Planning Commission Issues Report

Subject: Change of Zoning Issues Report

Petition: **P.Z. 02-2015 Falling Leaves Estates II (1925 & 1921 Wilson Ave)**

RE: P.Z. 02-2015 Falling Leaves Estates II (1925 & 1921 Wilson Avenue)

Falling Leaves Esates II
 CHESTERFIELD, MISSOURI
 Preliminary Development Plan

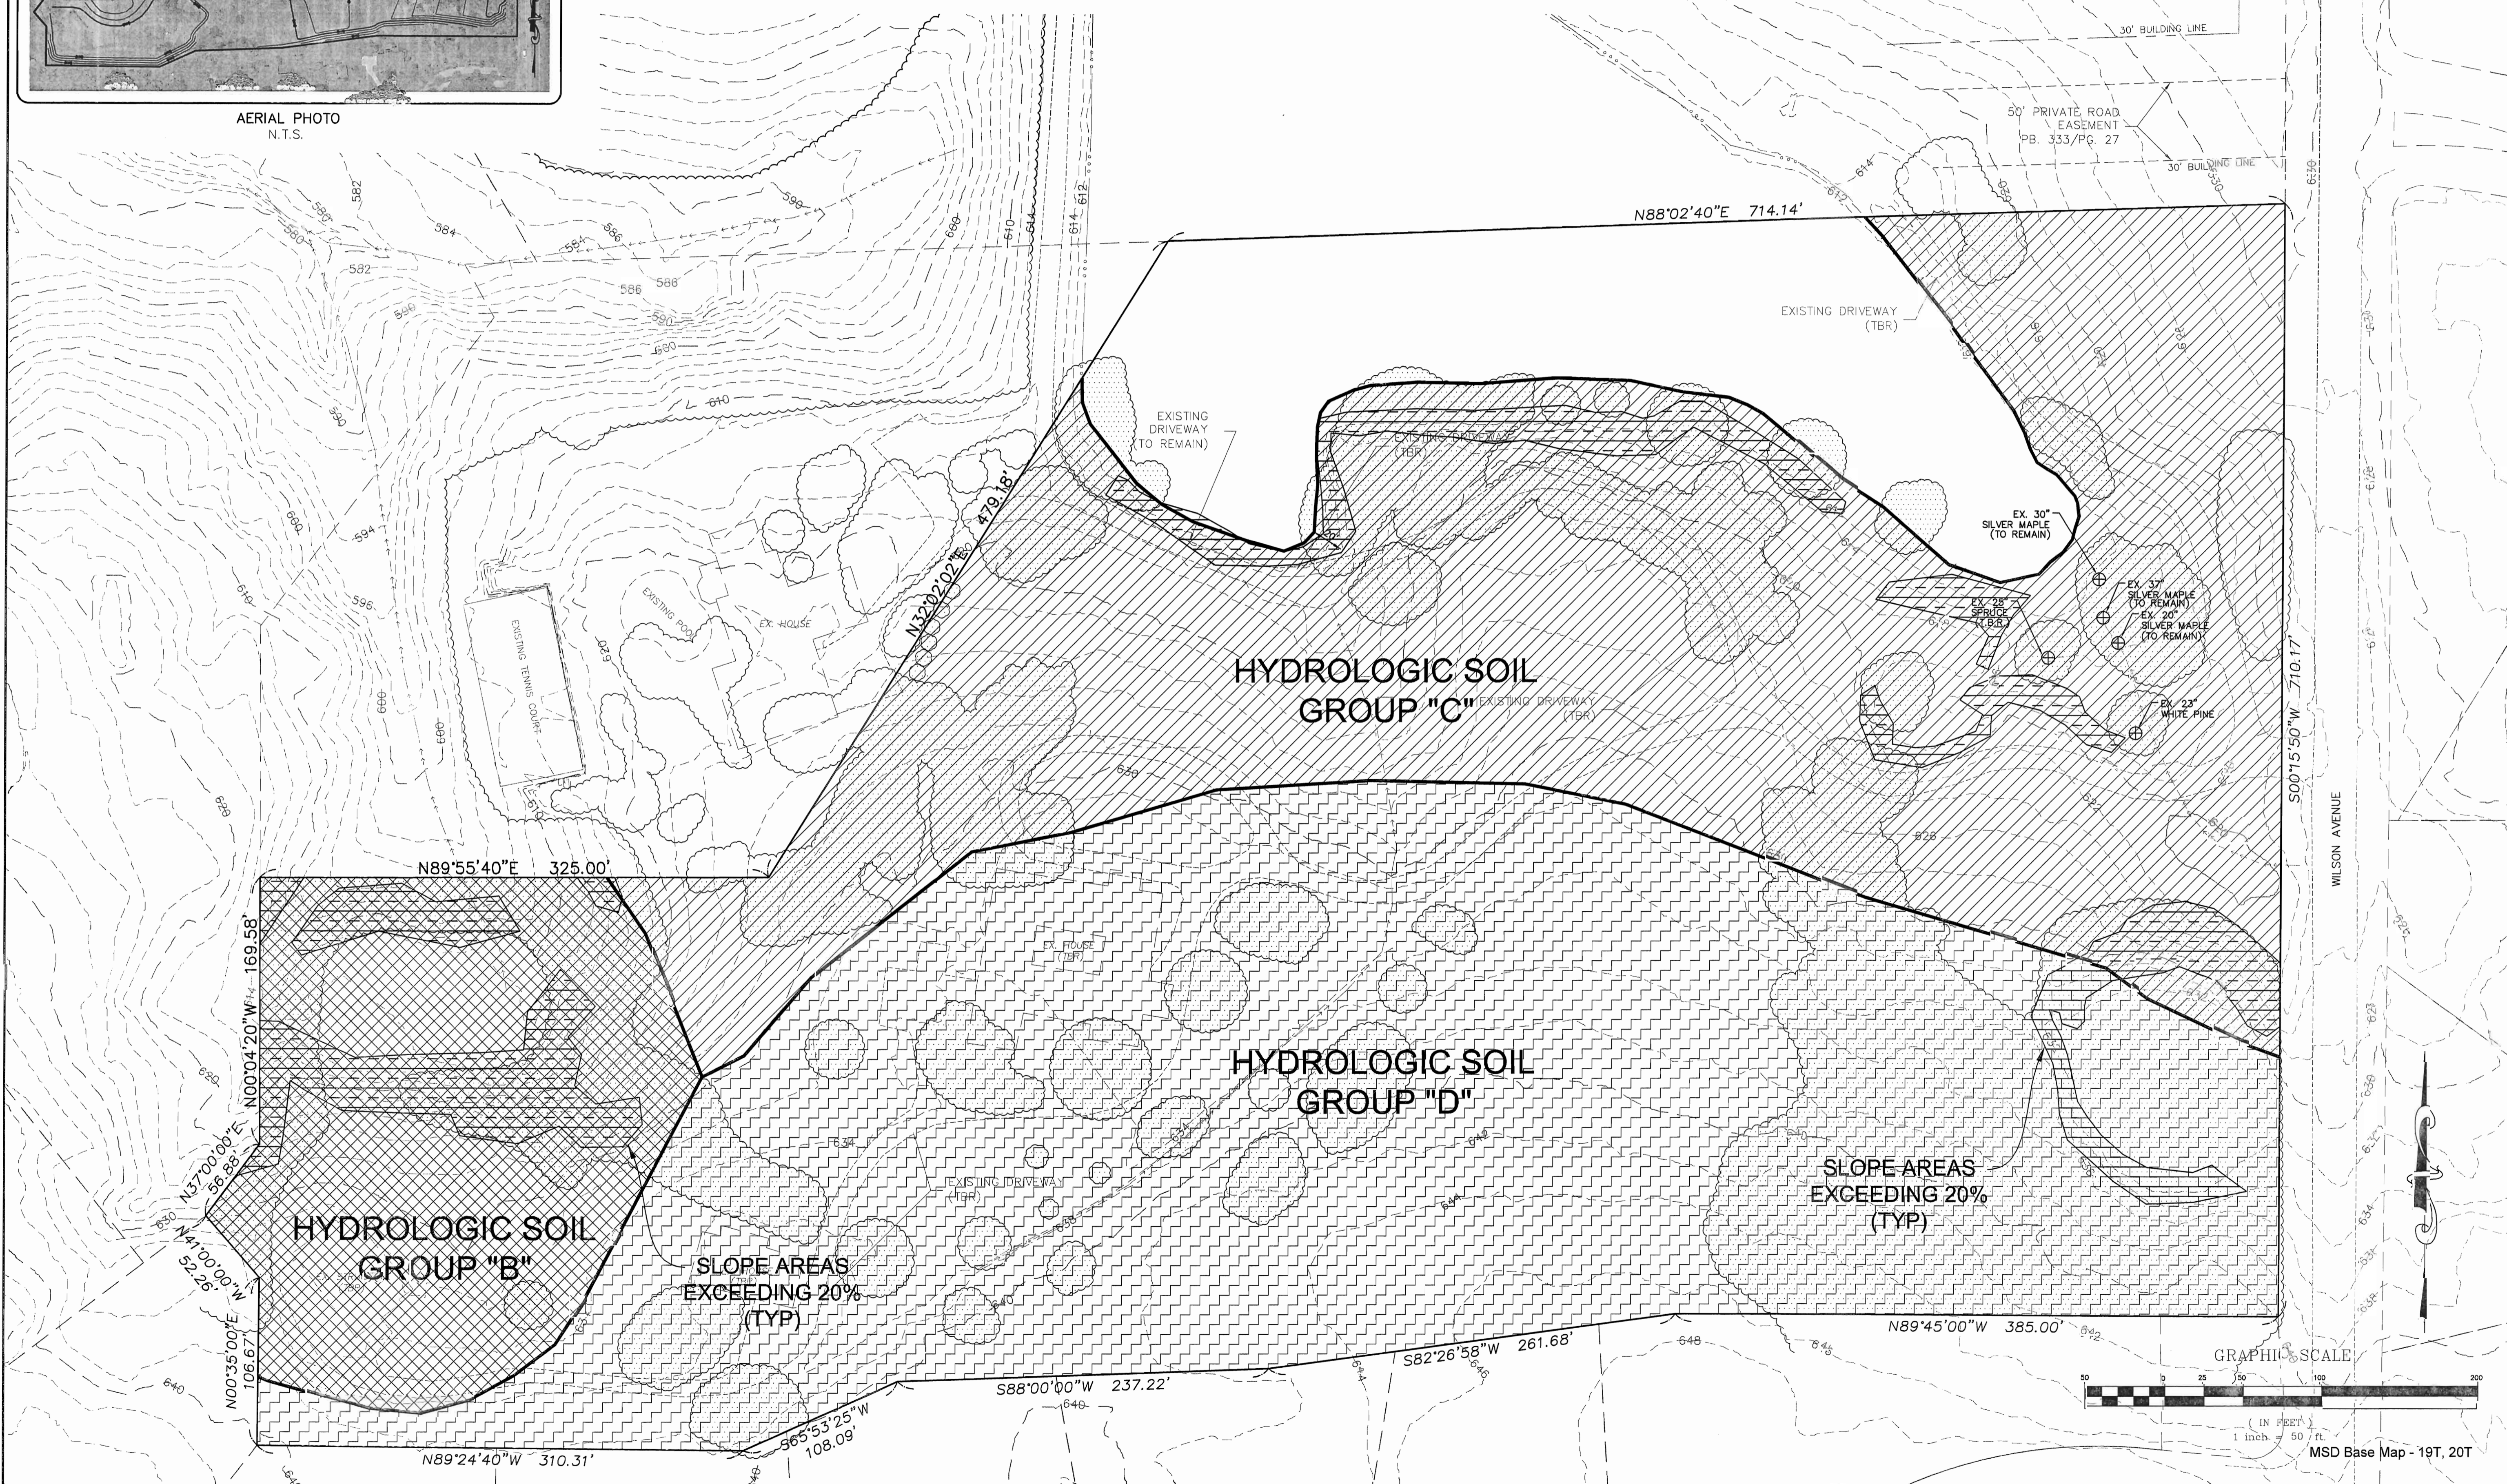
10. Section 31-03-04.K.7(c) of the City of Chesterfield Municipal Code requires a PUD perimeter buffer be provided at a minimum of thirty (30) feet in width. The perimeter buffer shall be composed of a combination of existing trees (where applicable), trees selected from the approved tree list from the City of Chesterfield Tree Preservation and Landscape Requirements, and any combination of low-lying shrubbery or other

- a. This minimum perimeter buffer width requirement is not being met, specifically along the northwest portion of the site, across from proposed Lots 9 & 10, between the proposed road and property line.

- b. The plan as submitted shows the proposed stacked detention and water quality features inside of the thirty (30) foot perimeter buffer. Provide MSD comments/approval regarding suitability of plantings on the slopes of the proposed basins or relocate these basins outside of the required buffer.

13. Provide a minimum five (5) foot wide sidewalk, conforming to ADA standards, along Wilson Avenue, across the entire frontage of the proposed development, including Lot 1. This sidewalk should tie into the existing sidewalk along the frontage of Wilson Farm Estates.

14. In addition, provide sidewalks on both sides of the interior, private drive.

15. Pedestrian access should be provided to the existing lake.

16. In addition, a minimum twenty (20) foot wide access easement to the common open space adjacent to the existing lake behind Lots 2 through 5 is required to allow access for future maintenance of the lake.

18. The current Preliminary Plan notes only twenty-seven (27) percent of the existing tree canopy will be retained; however the City of Chesterfield Municipal Code requires thirty (30) percent be retained. During the Public Hearing, the petitioner stated the possibility of meeting this requirement. Please provide clarification on what percentage will be retained.

19. Update the title of Sheet 2.1 to read "Preliminary Development Plan" and remove Sheet 3.1.

See Revised Plan. Petitioner now complies with this requirement.

See Revised Plan. MSD comments will be provided during the Site Plan process.

See Revised Plan. Petitioner complies with this request.

See Revised Plan. Petitioner complies with this request.

See Revised Plan. Petitioner will provide a pedestrian access to the common open space adjacent to the lake and mark it with a monument and small bicycle/stroller parking area. The open space itself will be passive and maintained so that residents may walk over it and enjoy it but no permanent walkway or trail will be provided.

See Revised Plan. Petitioner complies with this request.

See Revised Plan. Petitioner now complies with this requirement.

See Revised Plan. These items have been addressed.

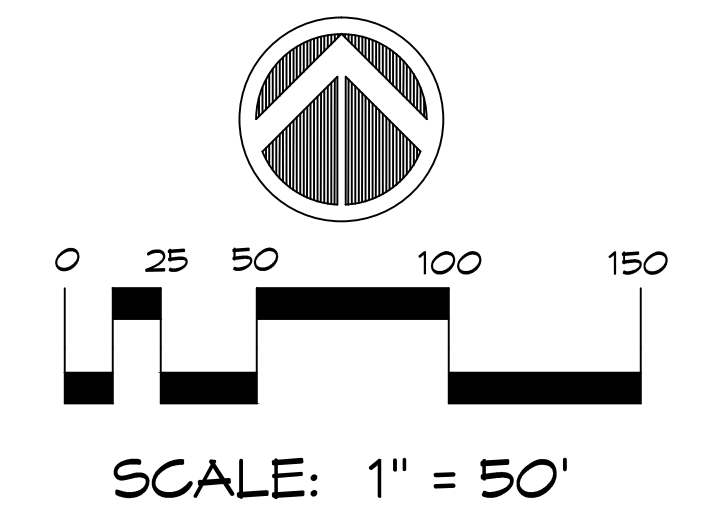
24. Update the title of the Tree Stand Delineation to read "Falling Leaves Estates II".

25. Remove the lot layout from the Tree Stand Delineation.

See revised Tree Stand Delineation.

See revised Tree Stand Delineation.
